**DOCUMENT 00 90 00
ADDENDUM**

ADDENDUM NO. [3] Date: February 26, 2021

**RE: WESTERN TECHNICAL COLLEGE
 SPARTA PUBLIC SAFETY EXPANSION
 11177 COUNTY HWY A
 SPARTA, WISCONSIN 54656
 HSR PROJECT NO. 20028**

9. Sheet C100 DEMOLITION PLAN 30 x42 attached hereto

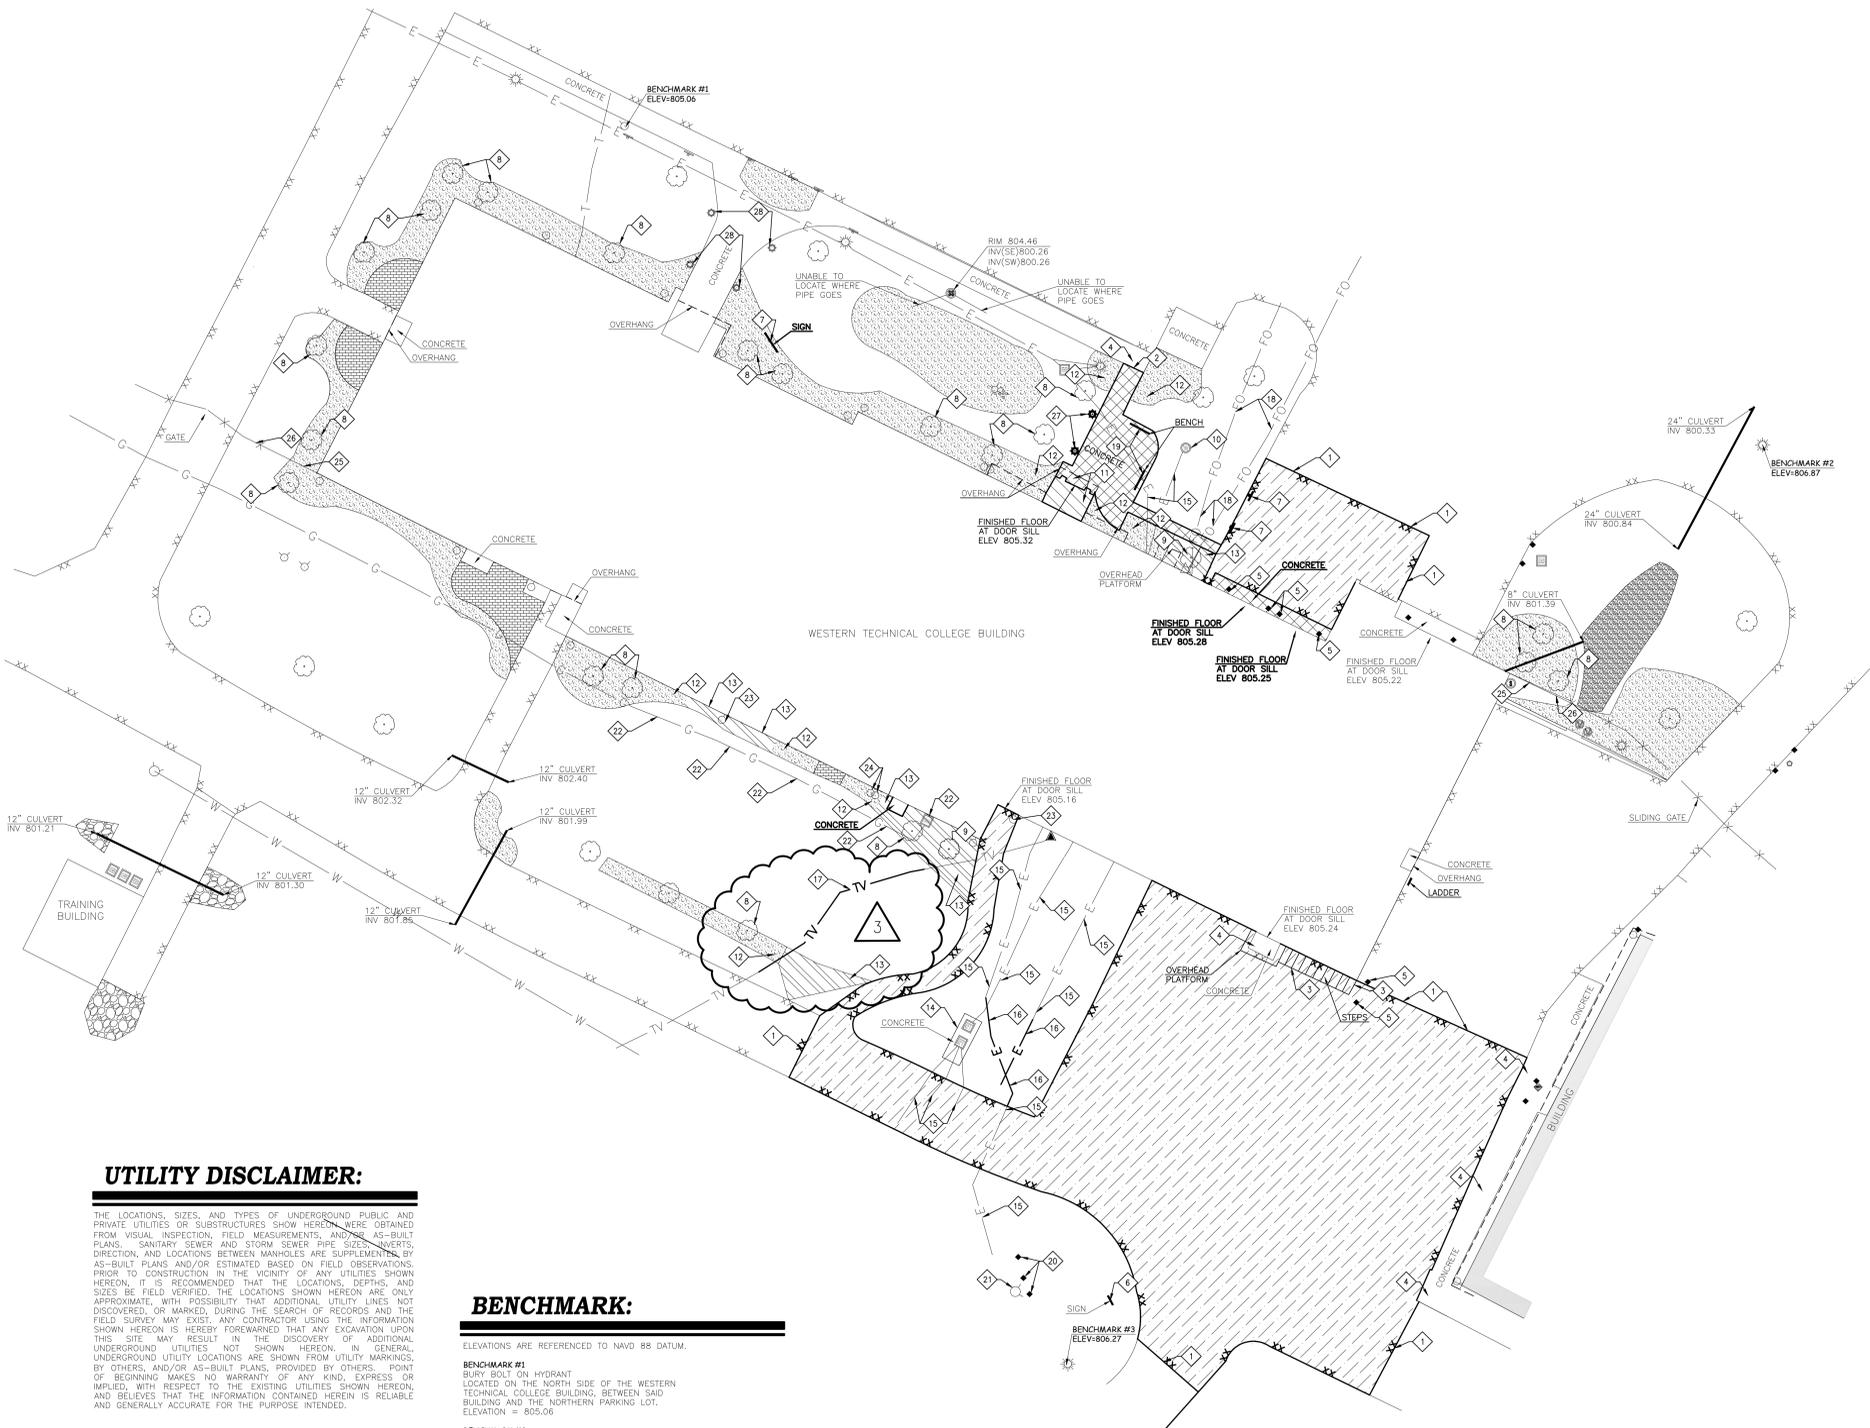
- a. Revisions clouded on Drawing
- b. Conditions regarding new rain garden.

1 FIRST FLOOR PLAN - AREA B
1/8" = 1'-0"

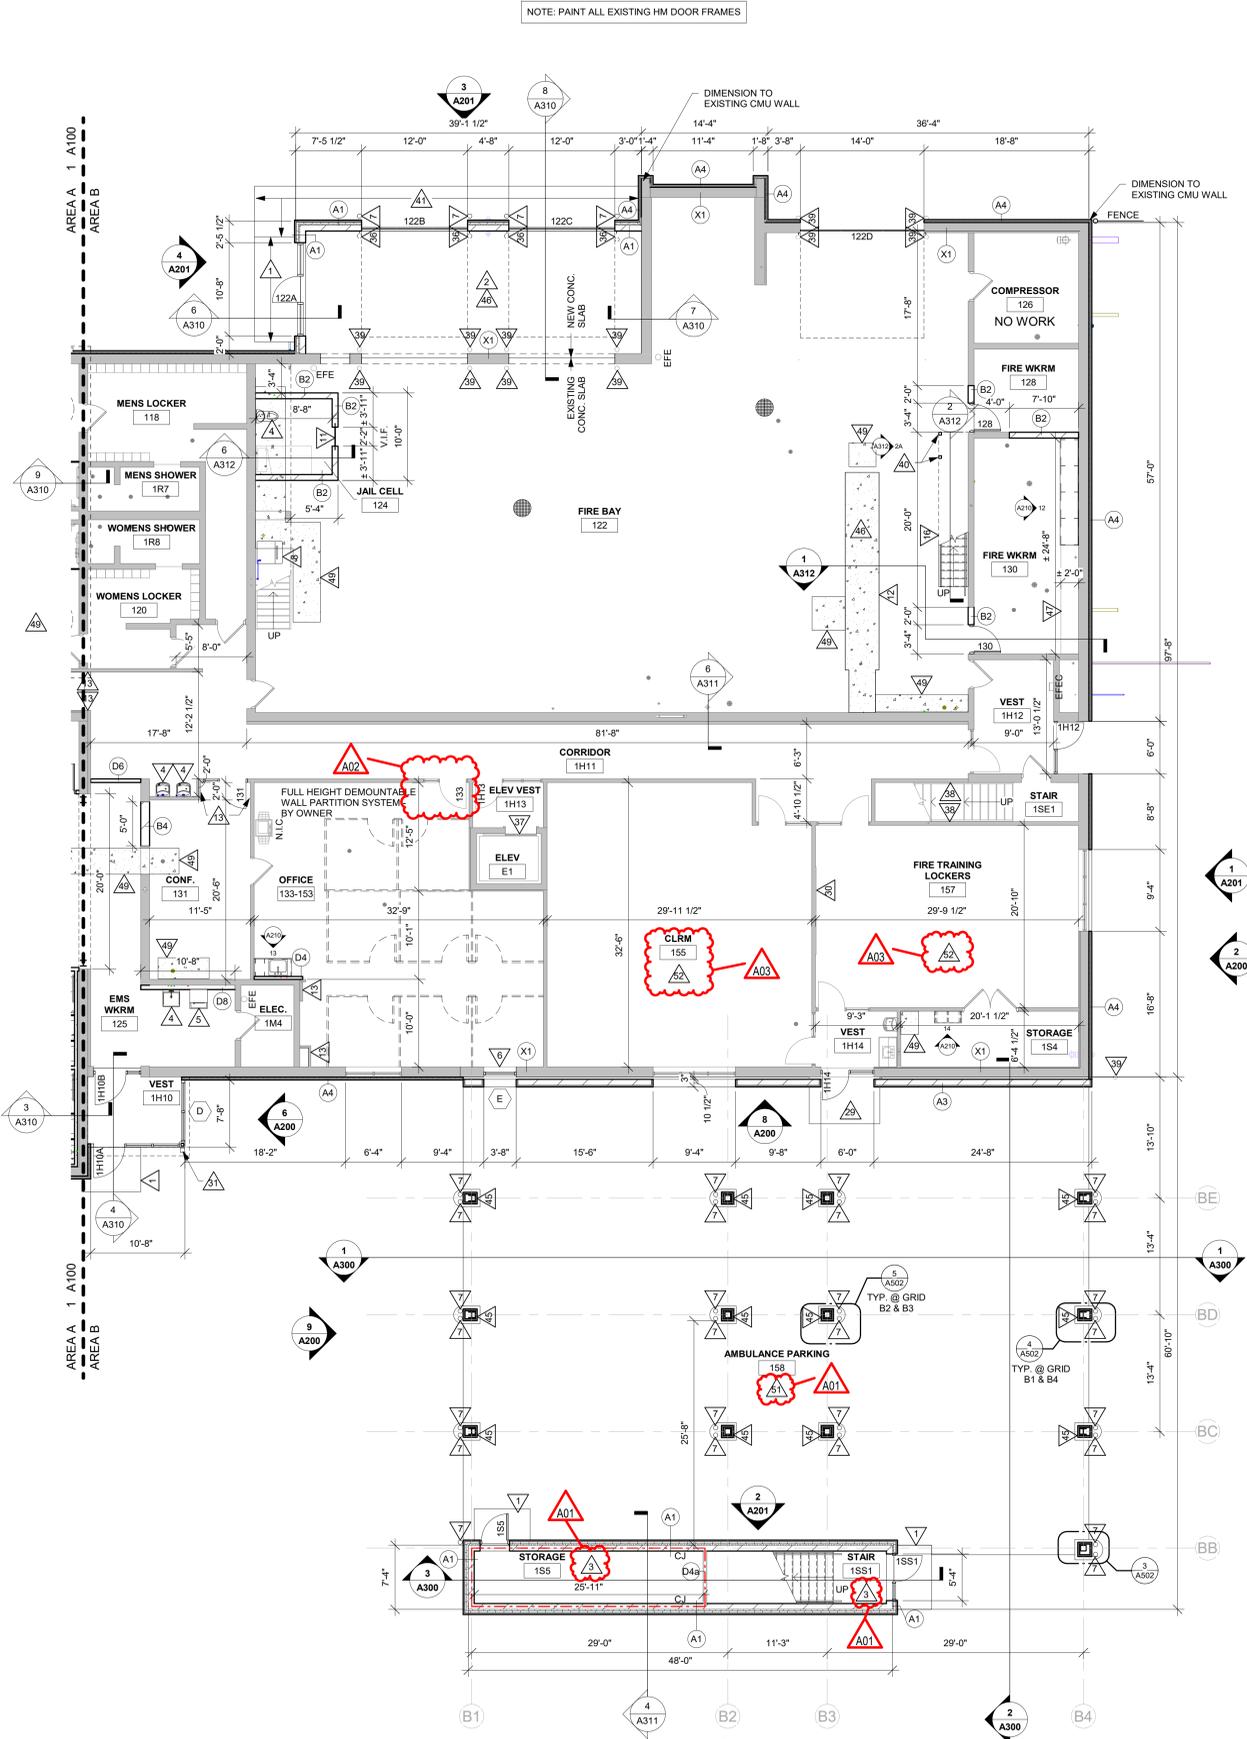
- a. Revisions clouded on Drawing
- b. Added notes regarding wall patching.

WESTERN TECHNICAL COLLEGE
SPARTA PUBLIC SAFETY EXPANSION
11177 COUNTY ROAD A
SPARTA, WI 54656
FIRST FLOOR REMOVAL PLAN - AREA A

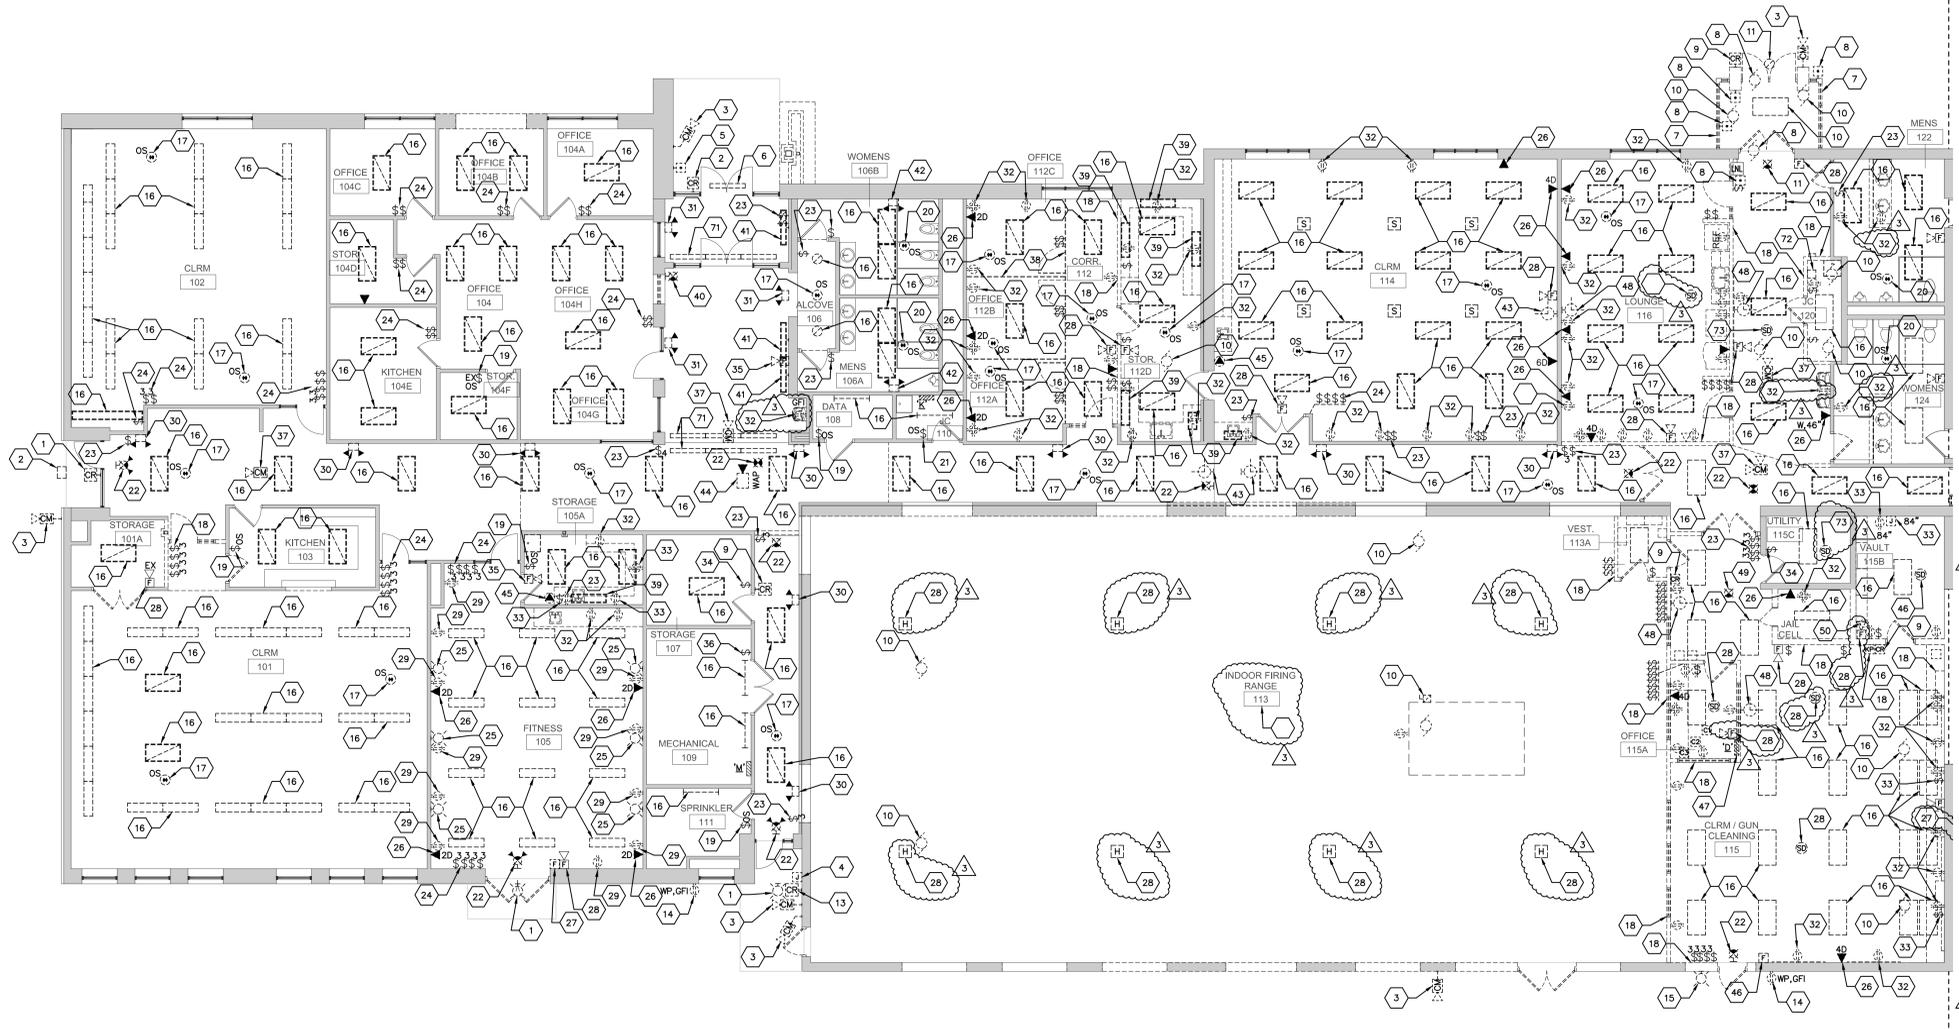
16. Sheet E002 – FIRST FLOOR REMOVAL PLAN - AREA A 30 x 42 attached hereto
 - a. Revisions clouded on Drawing
 - b. Refer to clouded note revisions with Addendum #3 Triangle symbol in the following rooms:

- vii. Women's Restroom #124
 - viii. Keyed notes #27 & #50 have been modified.
17. Sheet E003 – FIRST FLOOR REMOVAL PLAN - AREA B 30 x 42 attached hereto

1 FIRST FLOOR REMOVAL PLAN - AREA B
E003 SCALE: 1/8" = 1'-0" 20-07-E-ED01

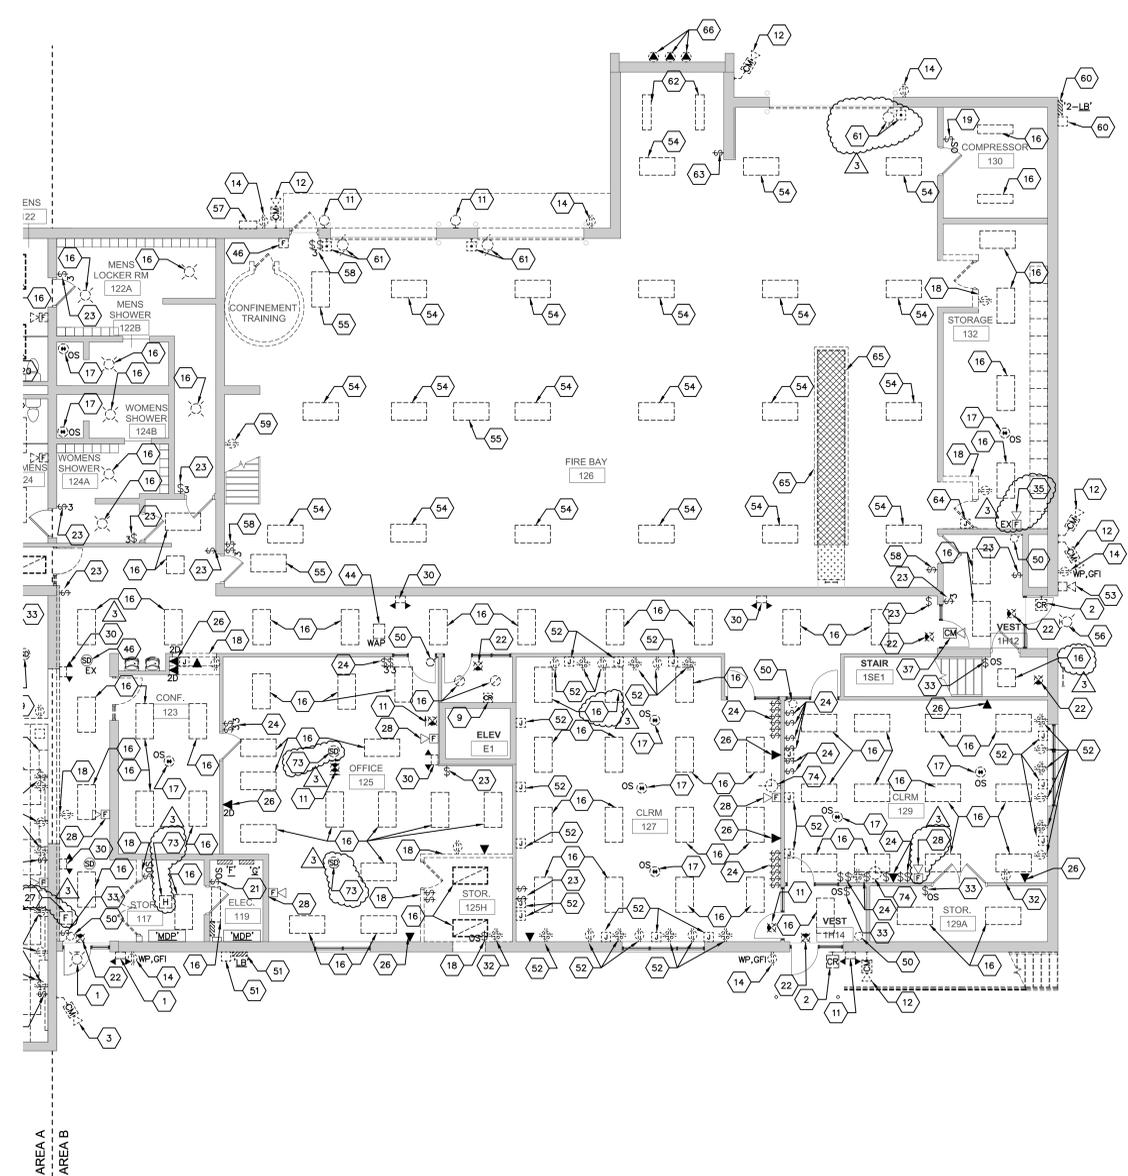
- a. Revisions clouded on Drawing
 - b. Refer to clouded note revisions with Addendum #3 Triangle symbol in the following rooms:
 - i. Storage Room #117

- ii. Office #125
 - iii. Fire Bay #126
 - iv. Classroom #127
 - v. Classroom #129
 - vi. Storage Room #132
 - vii. Keyed notes #27 and #50 have been modified.

1 FIRST FLOOR POWER PLAN - AREA A
SCALE: 1/8" = 1'-0"
20-07-E-PP01

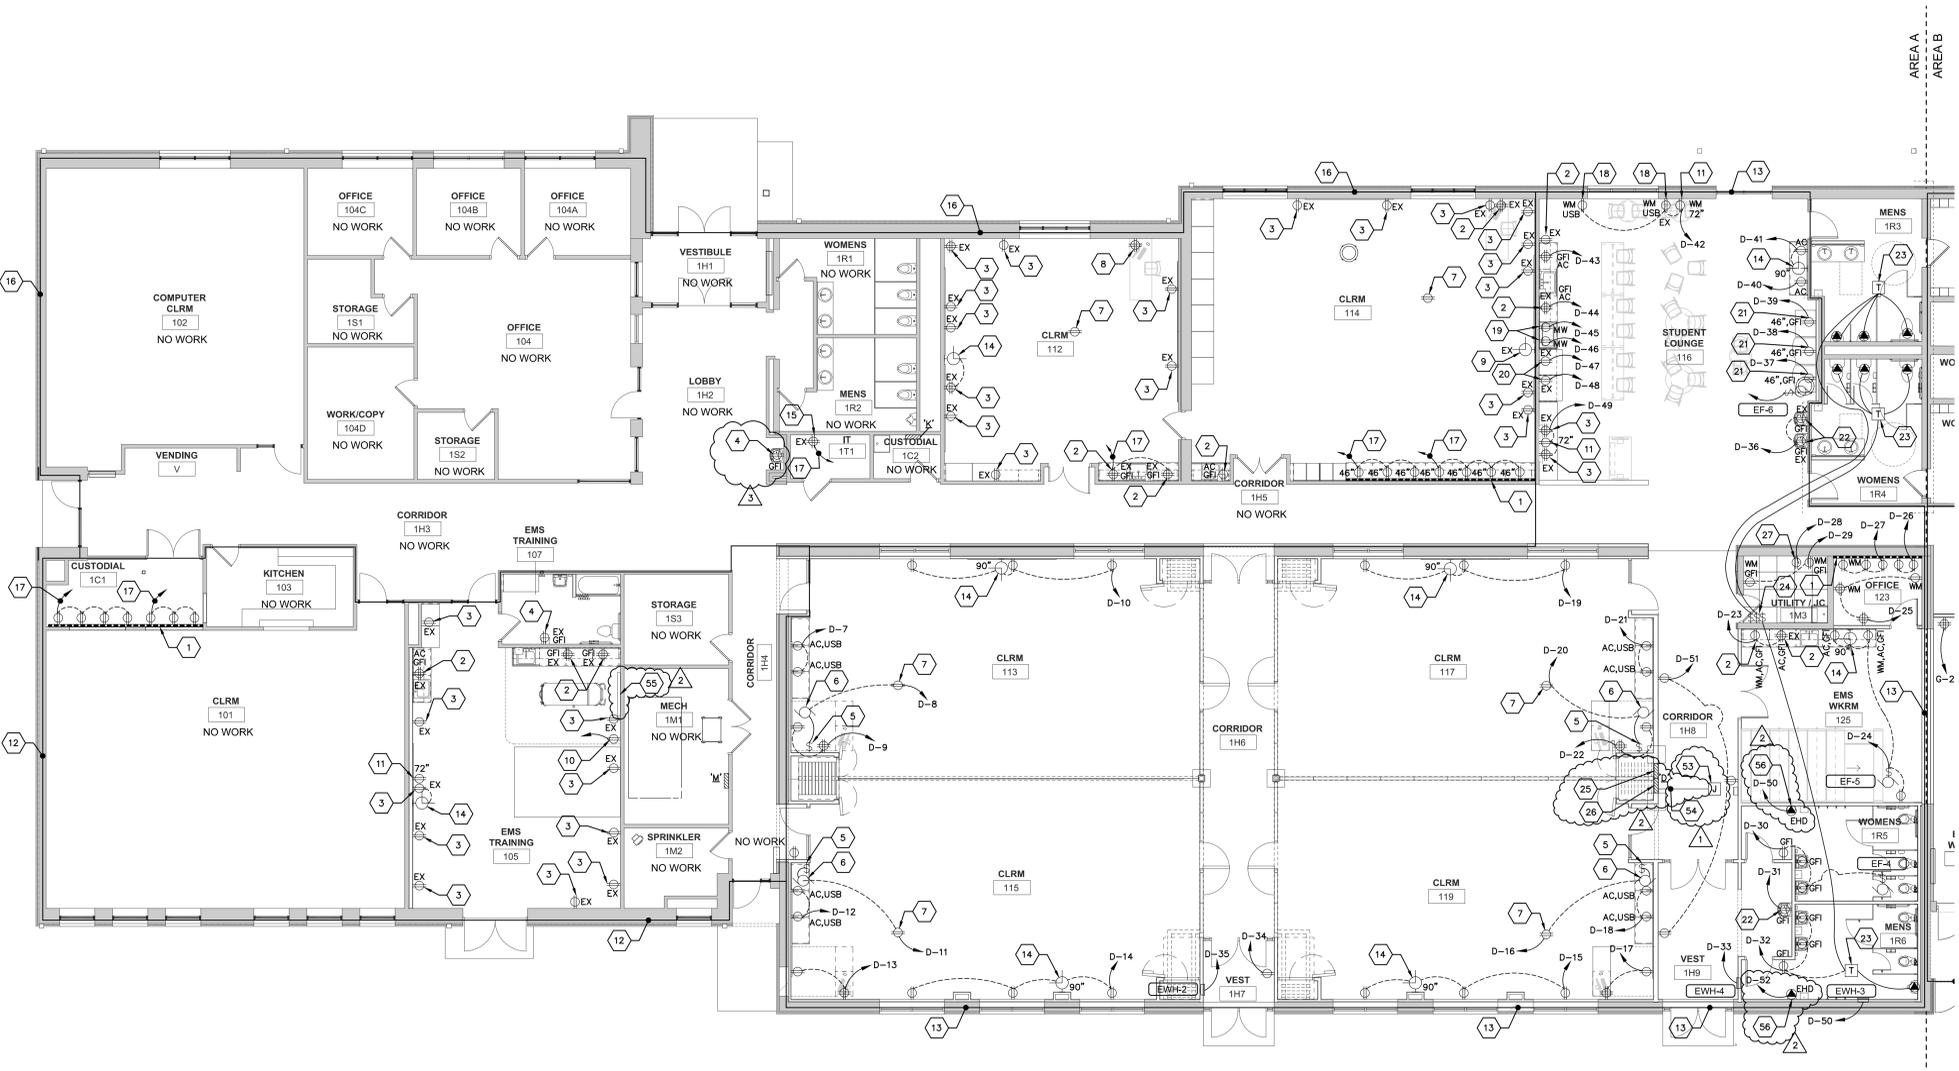
- a. Revisions clouded on Drawing
 - b. In Lobby 1H2; provide a GFI receptacle for electric water cooler, reuse existing branch circuit wiring. Refer to clouded change with Addendum #3 triangle symbol.
